SUBJECT: Entergy Response to NRC Request for Additional Information (RAI),  
Regarding the Heavy Loads License Amendment Request (TAC NO.  
MF3237)

Entergy Nuclear Operations, Inc.  
Pilgrim Nuclear Power Station  
Docket No. 50-293  
License No. DPR-35

LETTER NO: 2.14.069

**Entergy Responses to NRC RAI on Pilgrim Proposed License Amendment on Heavy Loads**

**Entergy Drawing C-174  
"Spent Fuel Storage Pool Floor Plan, Wall El. & Details"**

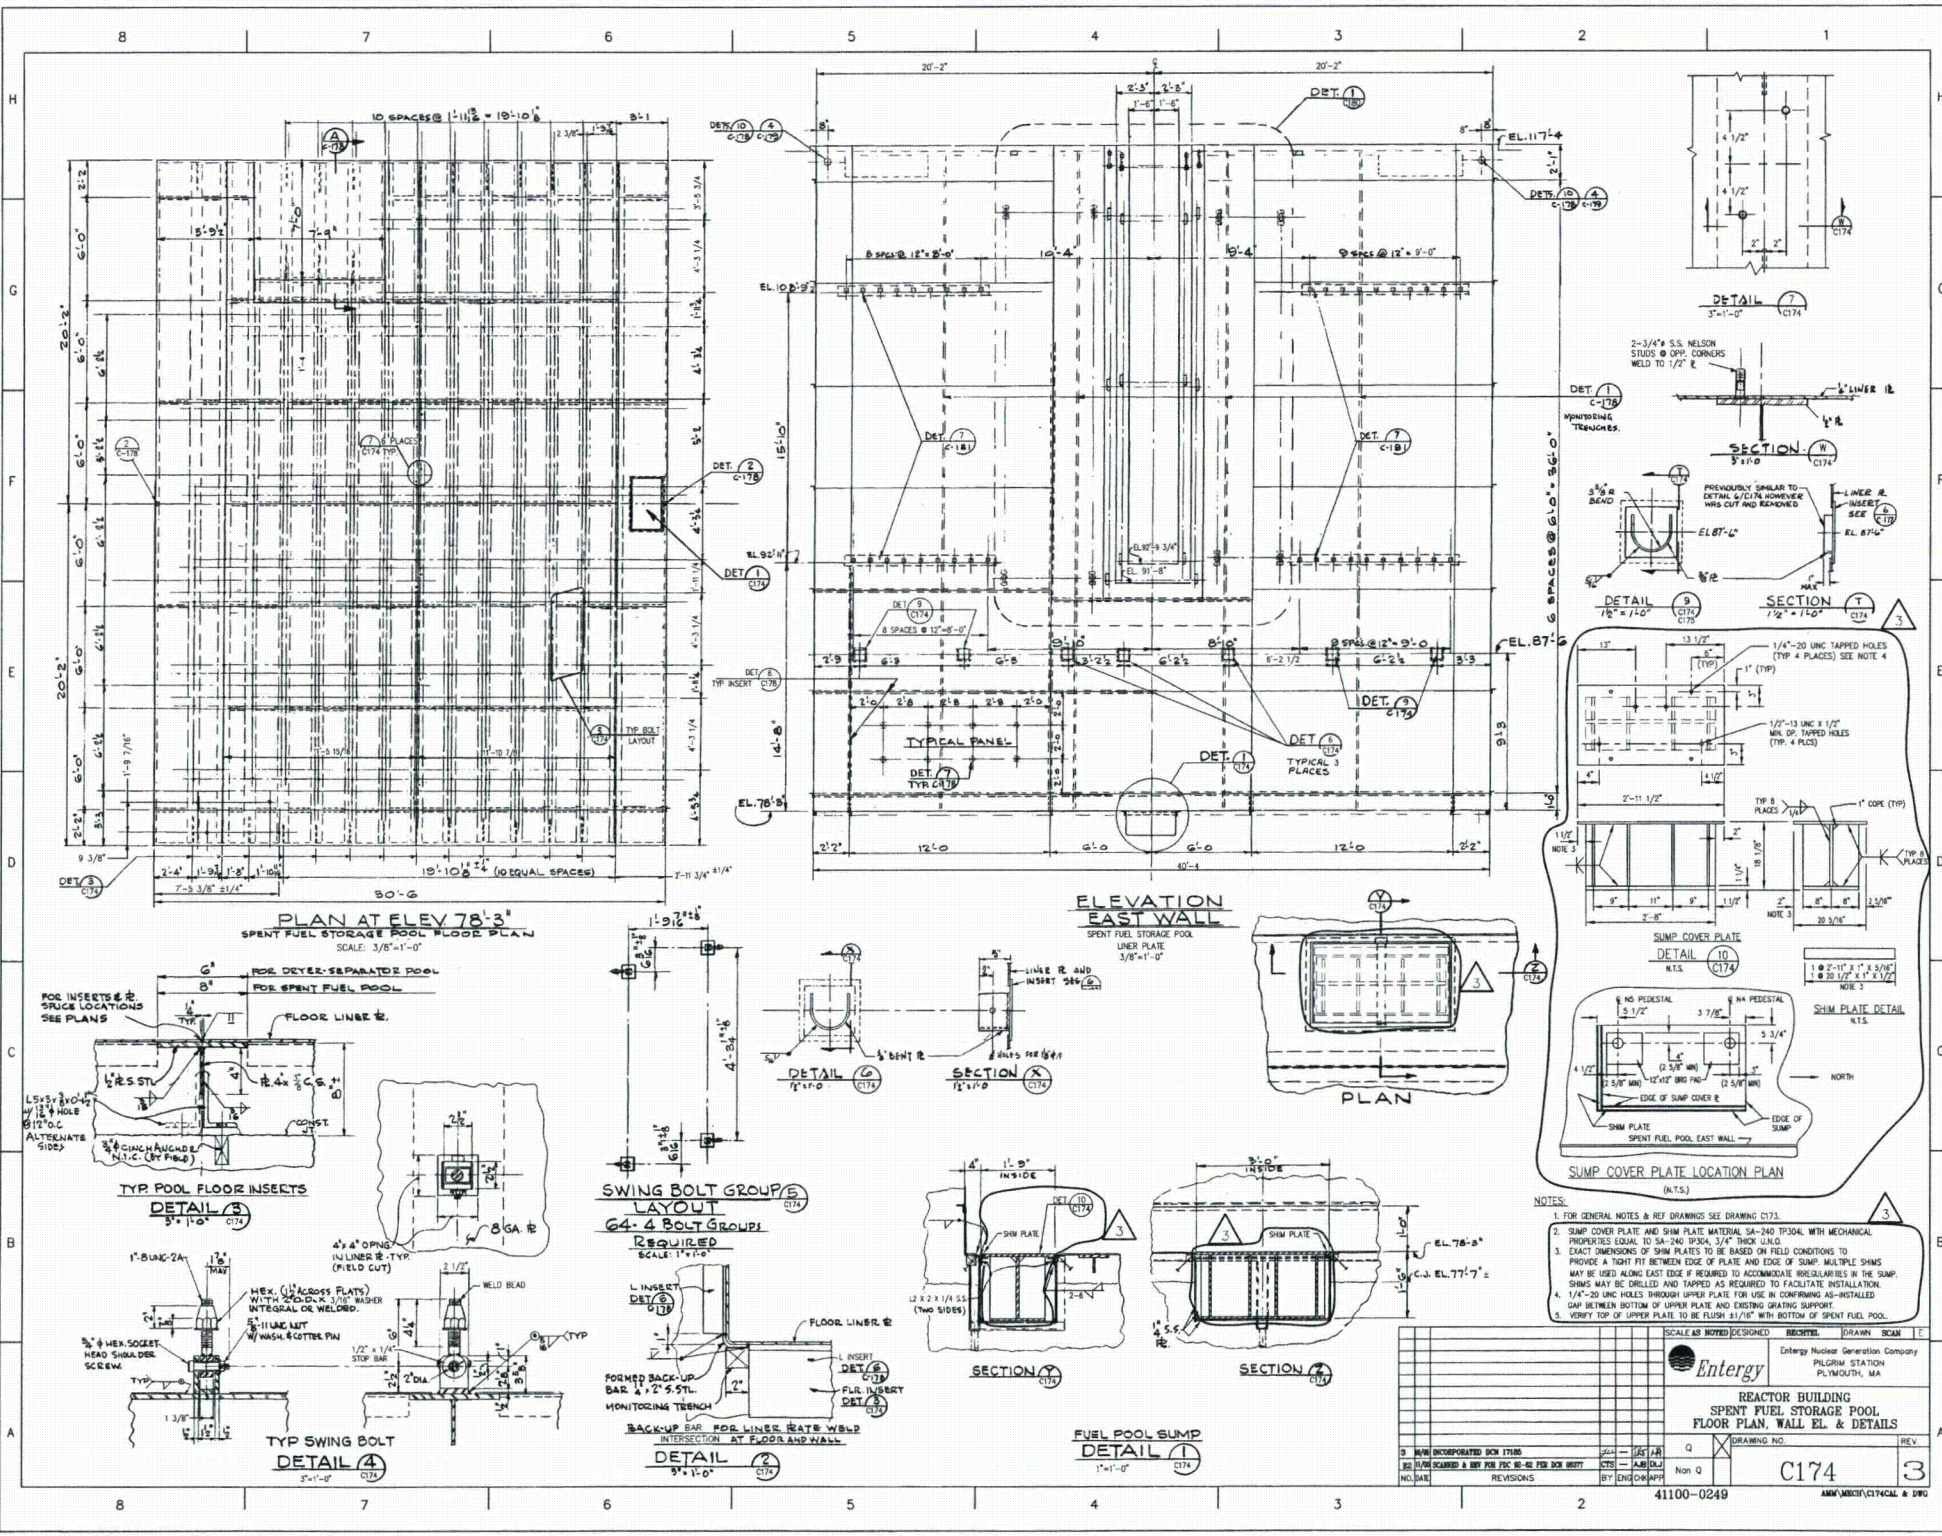
Although the use of a new single failure proof crane precludes the need to consider a cask drop, the increased weight of the MPC relative to the transport cask and the design of the leveling platform affect the loading on the SFP liner. Describe any analysis completed to verify the SFP liner integrity during MPC loading operations, including the mechanical loads considered (dead, live, and seismic), design features of the leveling platform that affect loading on the SFP liner, important analysis assumptions, and analytical results.

The principal design drawings for the Spent Fuel Pool liner system are C-174, C-175 and C-178 (References 6, 7, and 8). Three (3) small vertical monitoring trenches formed in the concrete are shown in each of the four walls of the Spent Fuel Pool. They communicate with horizontal monitoring trenches running along the perimeter of the floor to wall intersection. The drawings for the Spent Fuel Pool floor liner do not show any interior monitoring trenches running beneath it. Drawing M-413 (Reference 9) shows the location of the drain piping connected to the fittings (See Detail 2 on C-178) that collect any monitoring trench flow. In the cask handling area, the 1" thick floor liner plate does have a horizontal monitoring trench at the intersection of the floor to wall liner as shown in Section A on C-178, but the trench is not in a zone of influence of pad bearing pressures.
